Willcox High School
GYM LOBBY, RESTROOM & LOCKER ROOM REMODELING AND WRESTLING ROOM ADDITION
240 N. Bisbee Ave, Willcox, AZ 85643

ADDENDUM NO: 2
April 25, 2025

1
x1.0

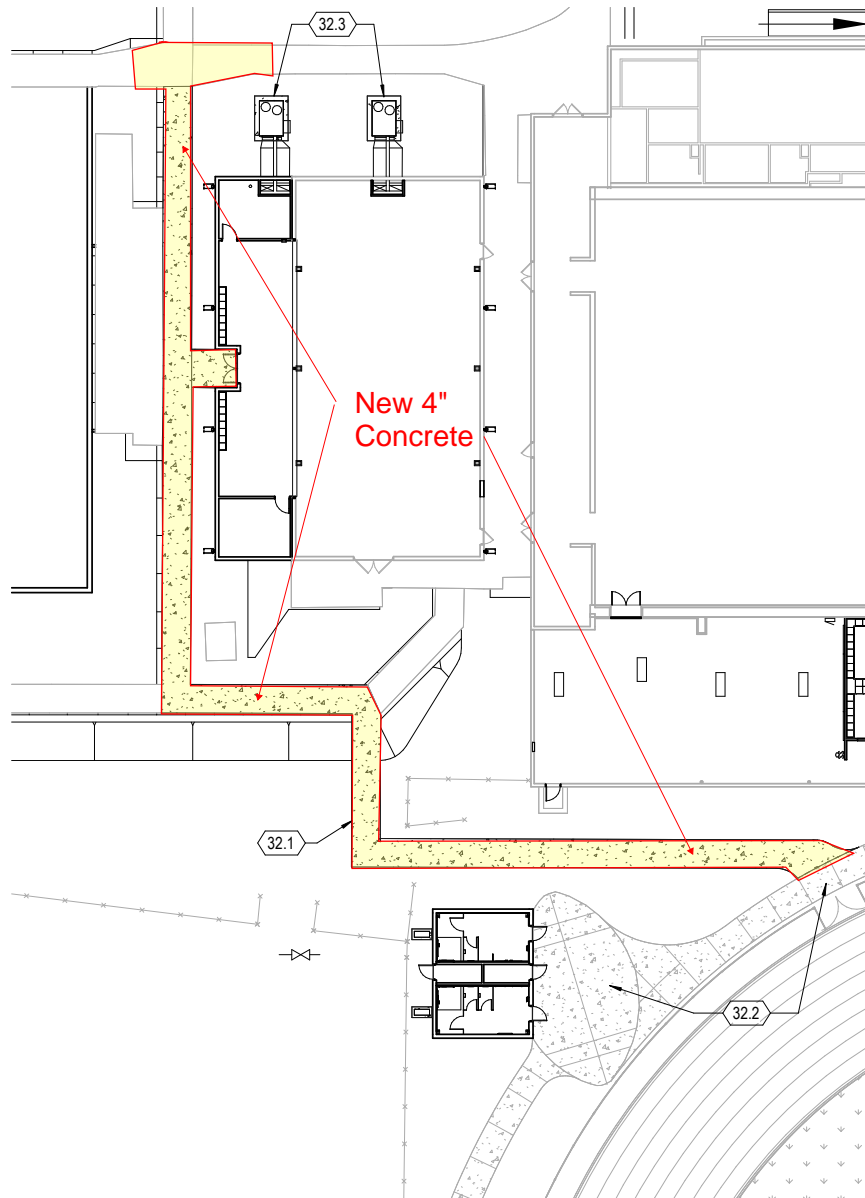
**ITEM 3**   Drawings, Sheet C1.5 Site Civil:
1. The existing sidewalk along the west side of the Wrestling Building shall be removed and replaced per Keynote 2. Please refer to the attached exhibit which highlights new concrete.

New 4"
Concrete
